UNITED STATES  
NUCLEAR REGULATORY COMMISSION  
WASHINGTON, D.C. 20555-0001  
January 5, 1999

SUBJECT: STAFF ASSESSMENT OF CRACKING IN UNISOLABLE SECTIONS OF HIGH PRESSURE INJECTION MAKEUP LINES AT OCONEE NUCLEAR STATION, UNITS 2 AND 3 AND OTHER BABCOCK AND WILCOX PLANTS  
(TAC NO. M98454)

ASSESSMENT ON THE OCONEE NUCLEAR STATION, UNITS 1, 2, AND 3  
HIGH PRESSURE INJECTION SYSTEM MAKEUP LINE WELD CRACK AND  
RELATED BABCOCK AND WILCOX OWNERS GROUP RESPONSE

FIGURE 1 - THERMAL SLEEVE  
2A1, 2B1, 3A1, 3B1, 3B2

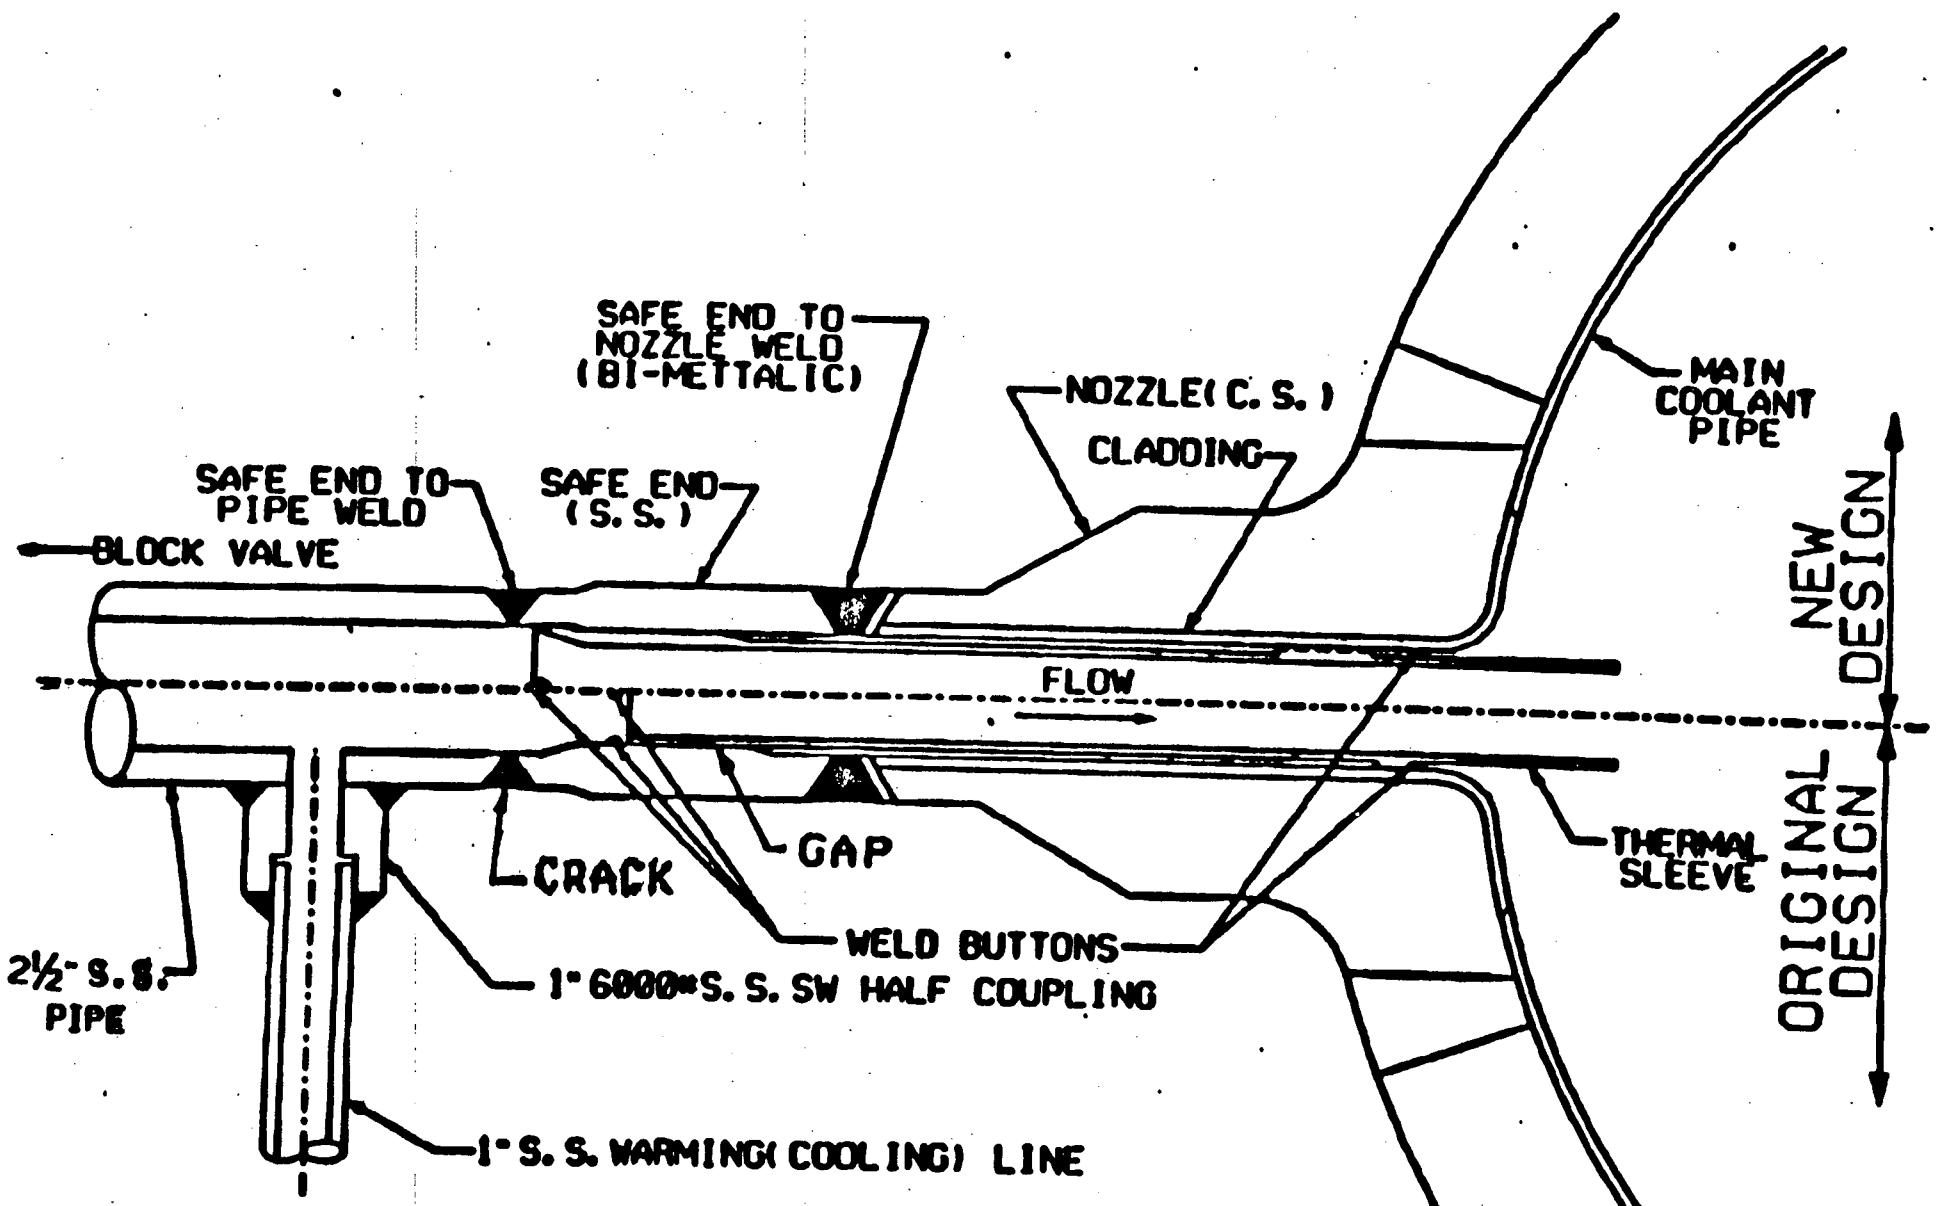
The Oconee 2A1 HPI/MU nozzle assembly consists of the HPI/MU 2.5-inch diameter pipe/safe-end/thermal sleeve (see attached Figure 1 - Original Design). The sleeve is attached by contact rolling to the inner surface of the safe-end. A 1-inch diameter "warming" line taps into the bottom of the HPI/MU pipe immediately upstream of the pipe/safe-end weld.

As corrective action, Duke replaced the cracked safe-ends and the safe-end/pipe welds in Oconee Units 2 and 3. The thermal sleeves were also replaced with an improved sleeve design, also shown in Figure 1 - Original Design. In addition, Duke assembled a Failure Investigation Process (FIP) team to determine the root cause of the event in Unit 2. The team concluded that Duke had failed to implement an effective HPI nozzle inspection program based on available industry recommendations, and had failed to effectively evaluate known problems (industry and in-house experience) and implement appropriate corrective actions from 1982 to the present. The FIP team published its findings in a report dated July 24, 1997 (Reference 6). The staff has examined this report and finds it thorough and complete.

FIGURE 2

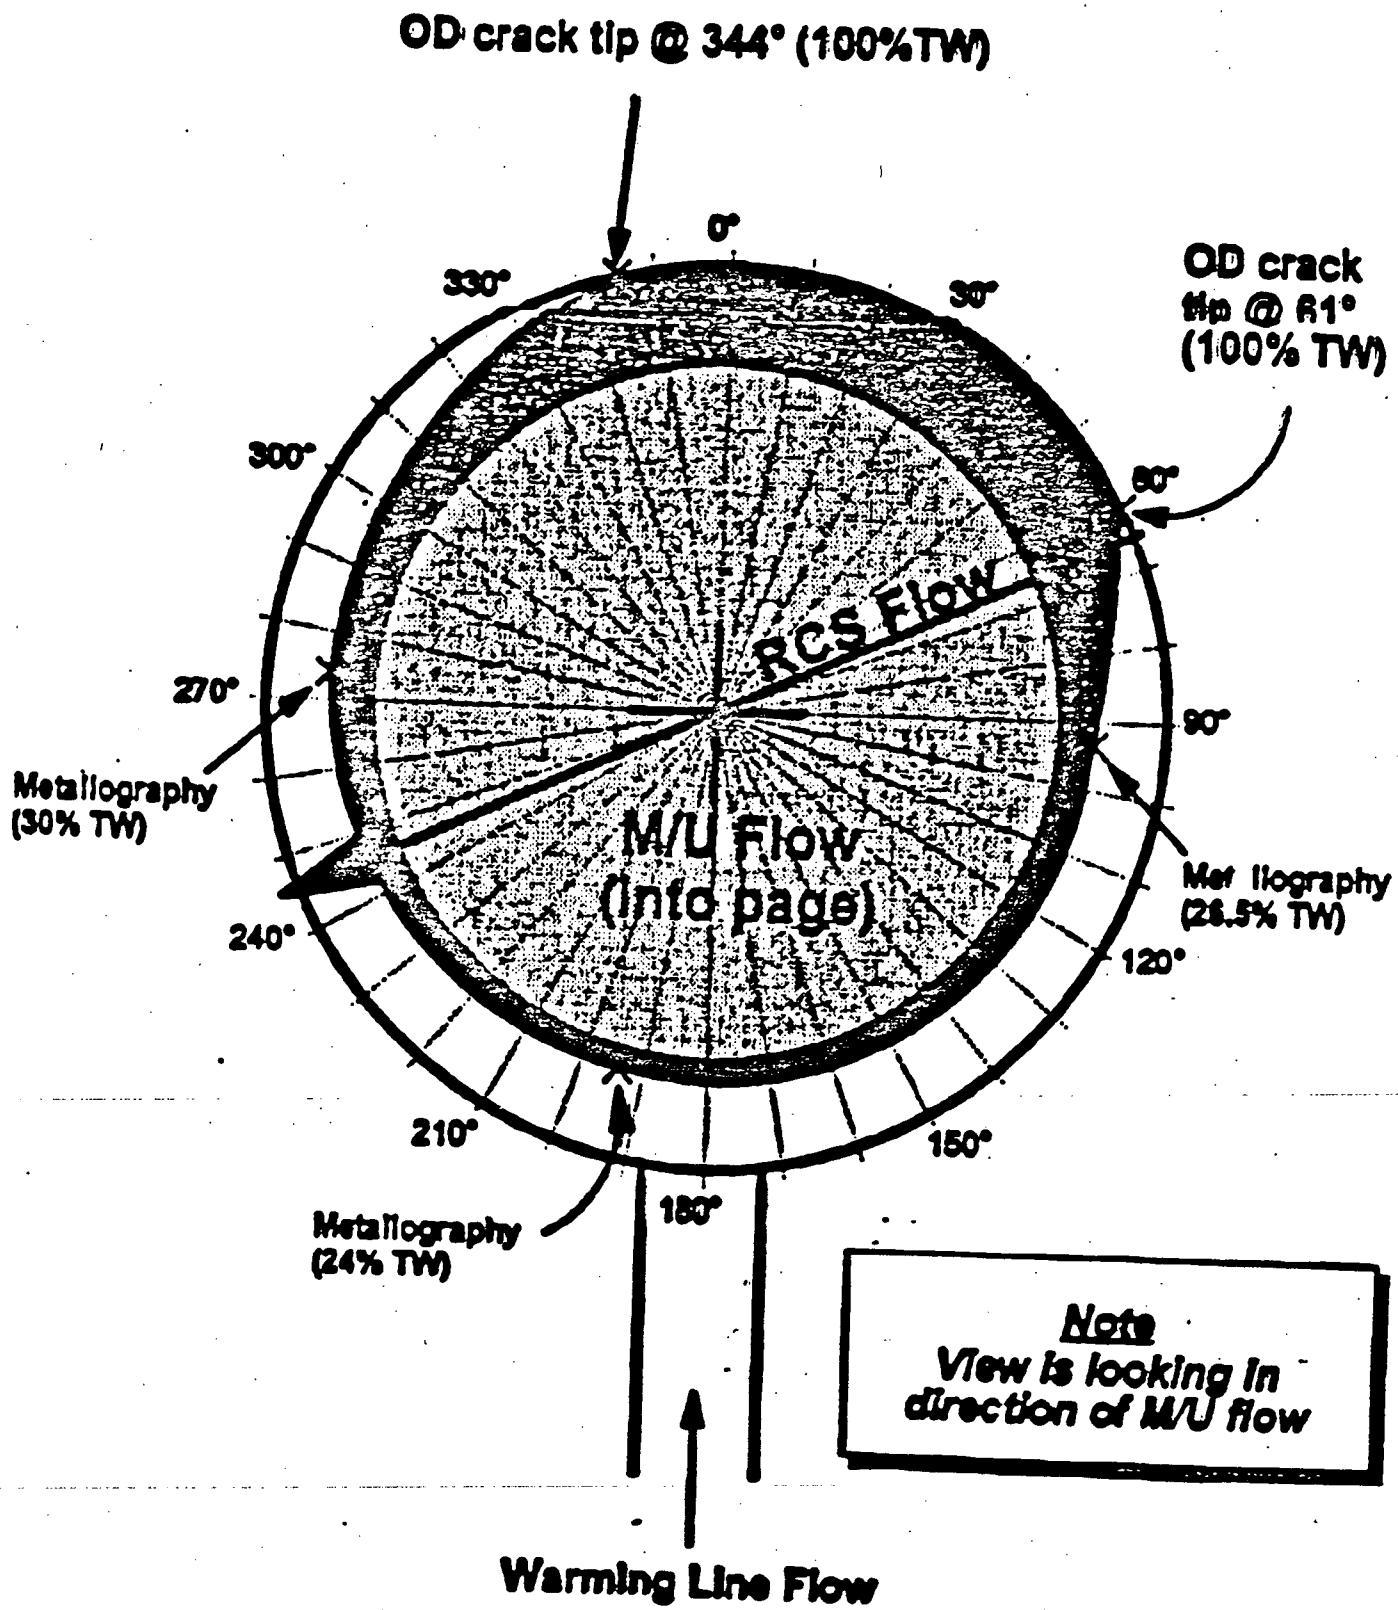
In Reference 3, Duke submitted the results of a metallurgical examination of the weld and determined that the crack consisted of a 360-degree inside surface flaw. The flaw depth increased gradually from about 30 percent into the wall until it became through-wall over a 77-degree arc length (see attached Figure 2). The examination also found a gap in the contact area between the thermal sleeve and the safe-end, indicative of loss of contact that caused the thermal sleeve in this line to loosen (see attached Figure 1). The thermal sleeve was found to be cracked with portions missing from the end that extends into the RCS flow path. Significant wear damage was also found at both the upstream (the rolled end) and the downstream end. In addition, small cracks were found in the pipe in the vicinity of the "warming" line nozzle.

FIGURE 3 - UNIT 1 THERMAL SLEEVE

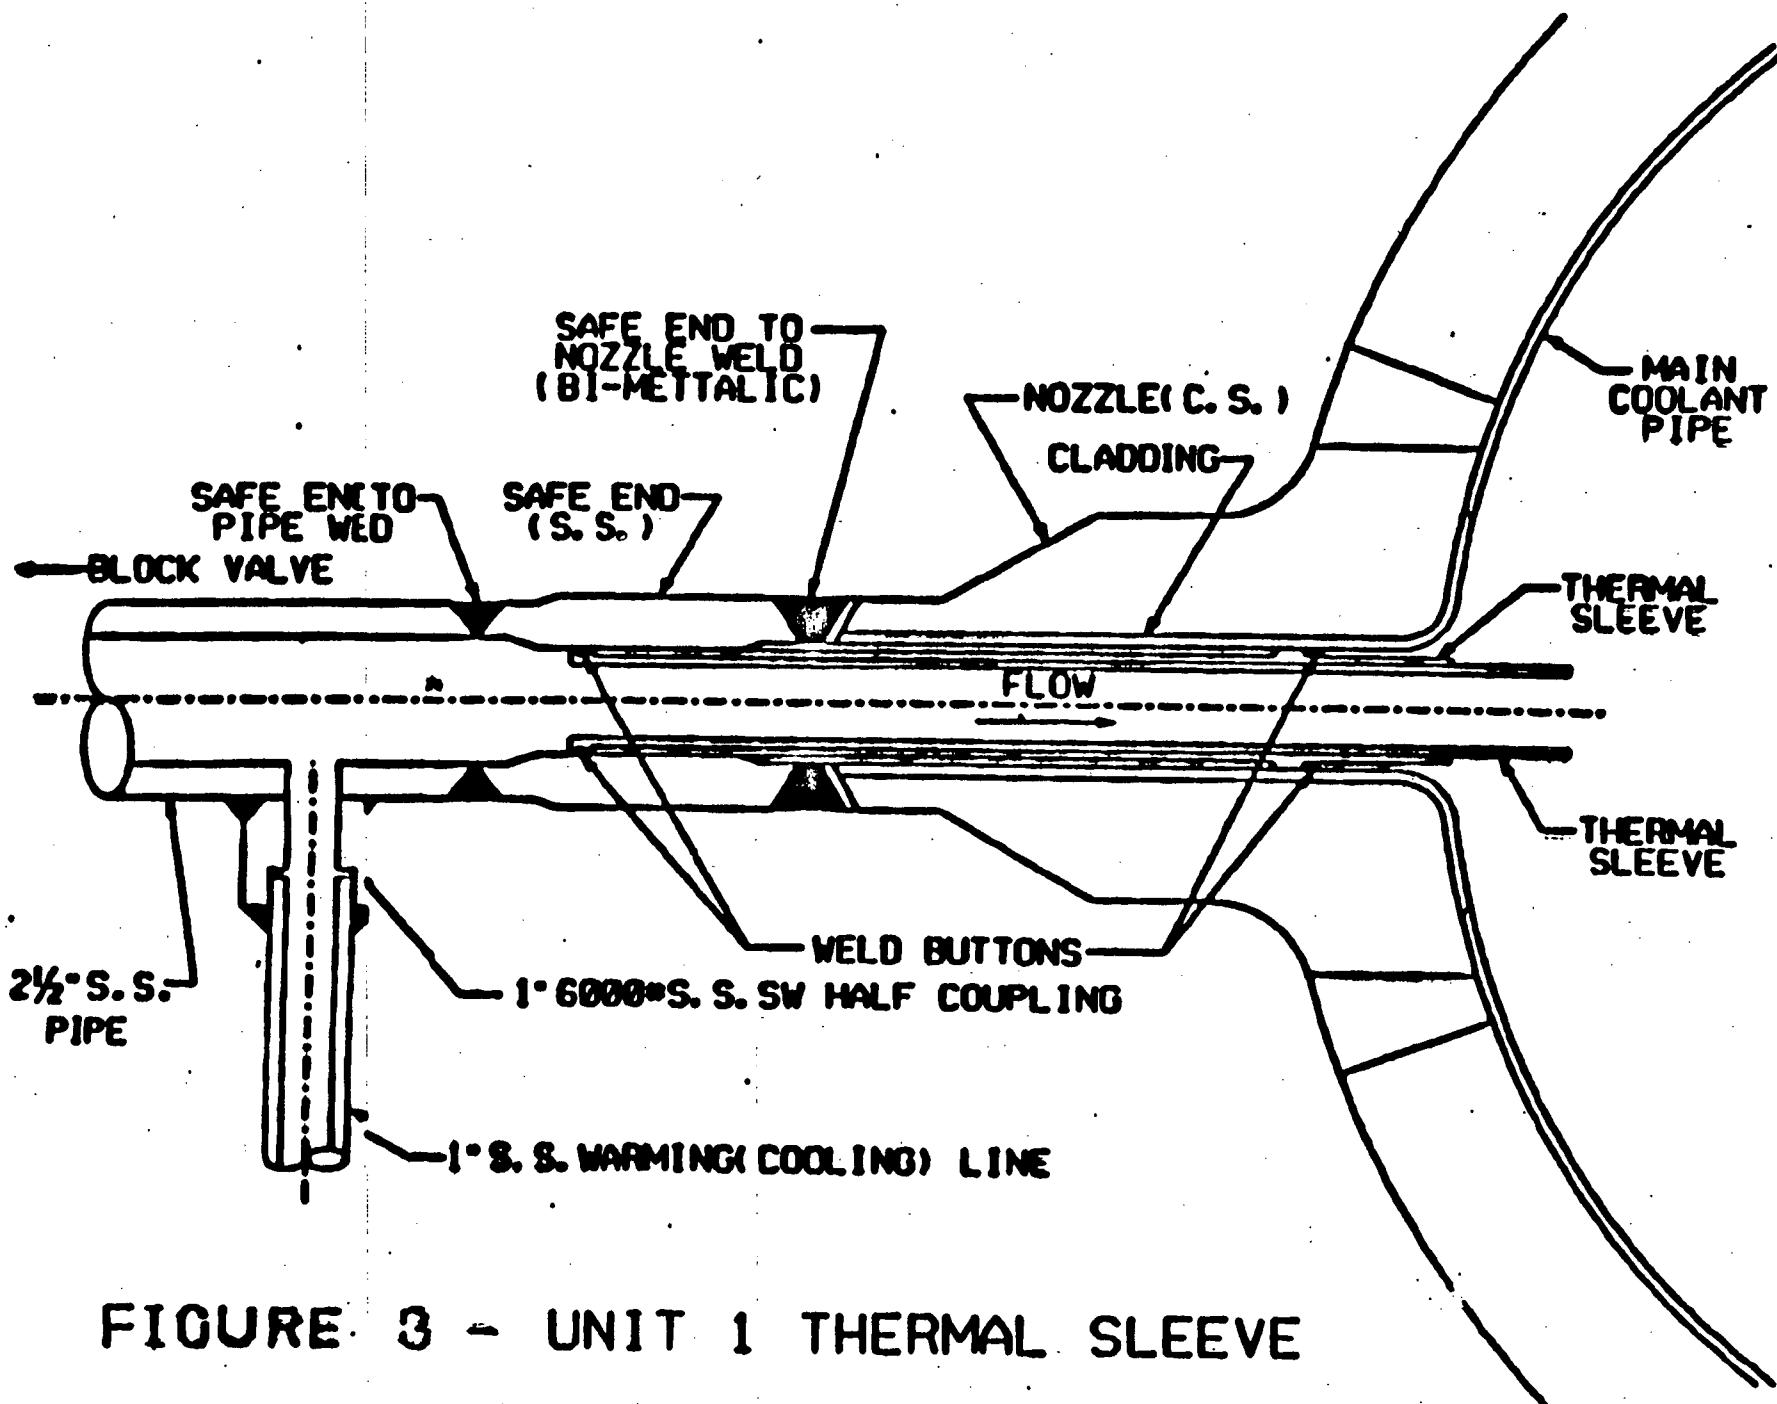
The Oconee Unit 1 nozzles have a double thermal sleeve design (see attached Figure 3). Radiographic inspection in the period from 1983 to 1989 indicated that no gap existed in three of the four thermal sleeves. A gap was found in the thermal sleeve in the 1B 2 HPI line, which had not grown during the inspection period. Advantages of the double thermal sleeve, as stated by Duke, include (1) greater stiffness, (2) greater thermal resistance, and (3) reduced flow area, with corresponding increased flow velocity. Duke concluded that this design resulted in the Unit 1 sleeves being less susceptible to thermal damage.
